Responses to comments posted by Referee #1

Responses to comments posted by Referee #2

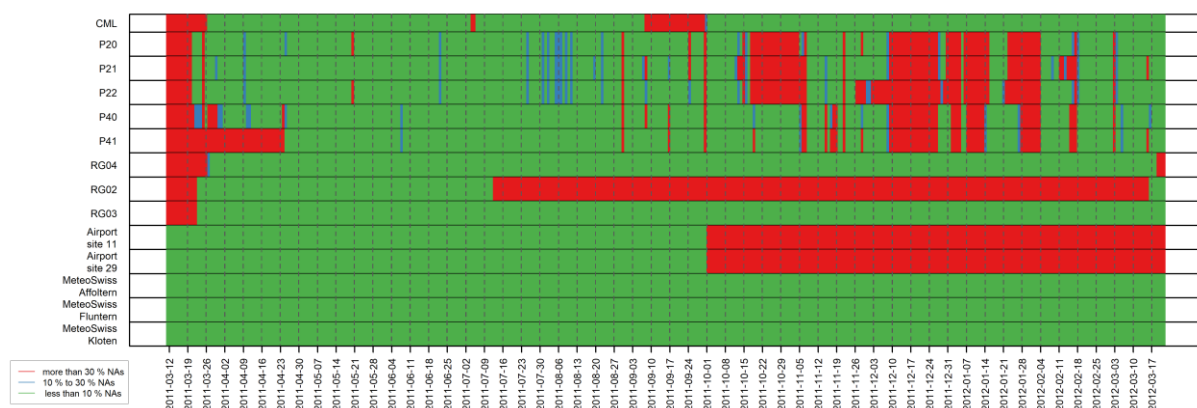
- For quick exploration and convenience of the data user a global overview of the data availability and data issues (flags) describe in section 2.5 should be added both to the manuscript and the event calendar view in the html viewer. This would be most important for the CML data and could be done e.g. with an additional figure in the manuscript showing time vs data availability/flags and likewise or with and an additional calendar view in the html viewer. The daily data availability charts are fine, but it takes rather long time to select e.g. the "best" summer month for a certain application. (see Fig. 2 in van Leth et al., 2018)

The figure was added to the appendix of the manuscript and in the html viewer.

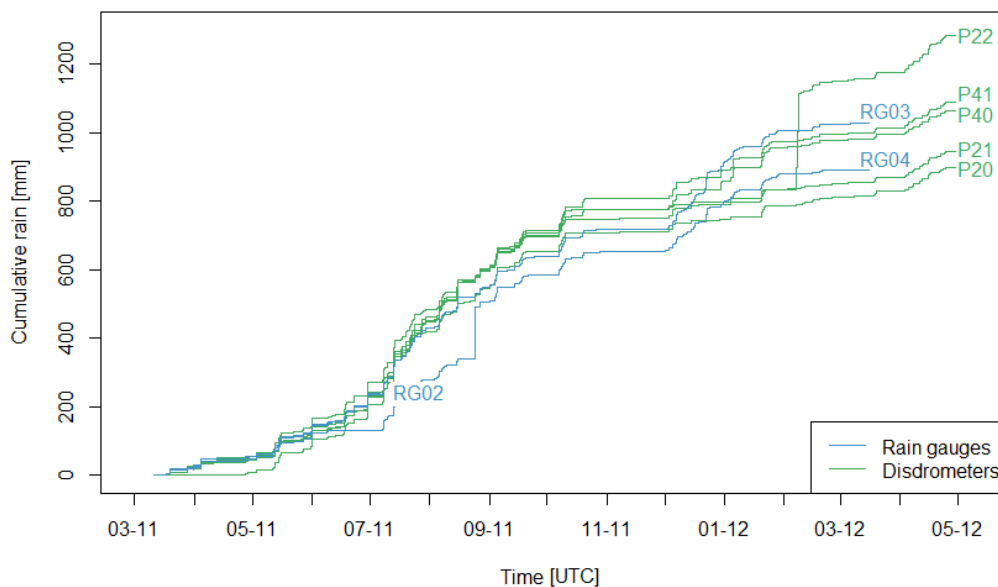
p.7 l.119: State again that the reading is instantaneous.

**The changes in the original text are in red:**

The sampling interval of the instantaneous readings was 4 s.

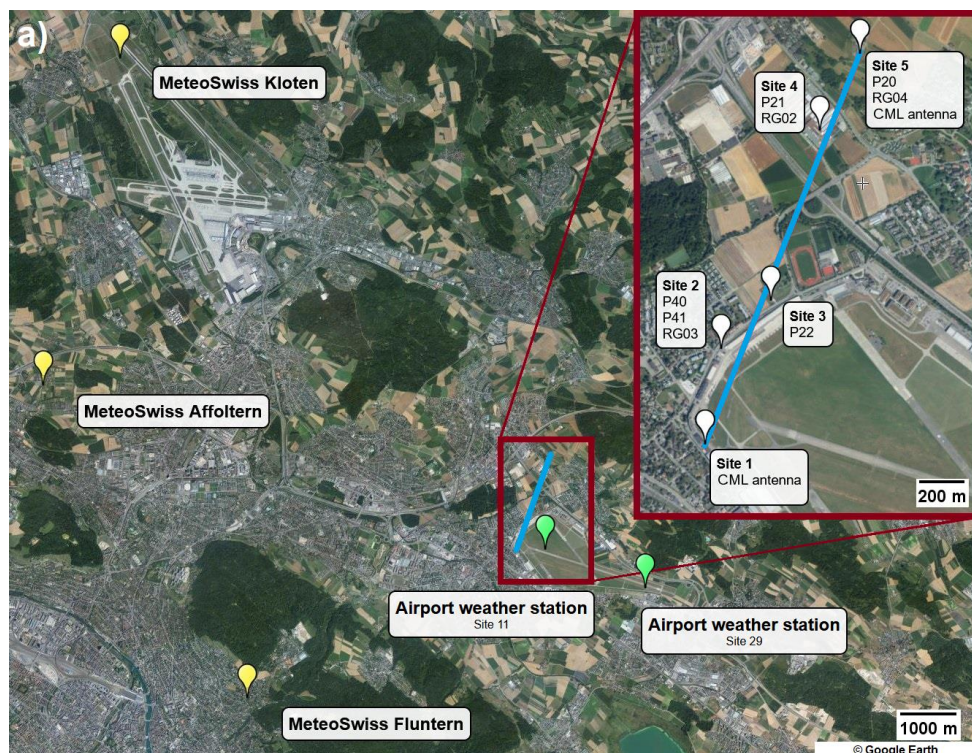
For the CML the information about the height above the ground is missing and of high importance for the use of the data for further studies.

p.4. Figure 1: Give an explanation to the abbreviations: P and RG.

p.4 l. 87 ff: CML- as already written – the height above ground is a needed information.

The changes in the original text are in red:

...The length of the link was 1850 m. The antenna at site 1 was deployed 6 m above ground and the antenna at site 5 was deployed 5 m above ground. Measurement intervals…

Figure 1 was extended, subfigure 1b provides a longitudinal terrain profile corresponding to the path of the CML.

Figure 1. a) Layout of the CoMMon field campaign. The radio units are deployed at the end sites (site 1 and site 5). The ~~direction of the link~~ path of the CML is in ~~red~~ blue. Disdrometer (P - Parsivel) and rain gauge (RG - rain gauge) positions are indicated by white pins. Site 2 contained two collocated disdrometers for data quality control. Except for site 3, all rain gauges have a collocated disdrometer. The MeteoSwiss weather stations (yellow pins) are ~~less than~~ within 6 to 10 km ~~away~~. Two additional weather stations (green) are located at the Dübendorf airport (site 11 and site 29). b) Longitudinal profile of terrain corresponding to the CML path.
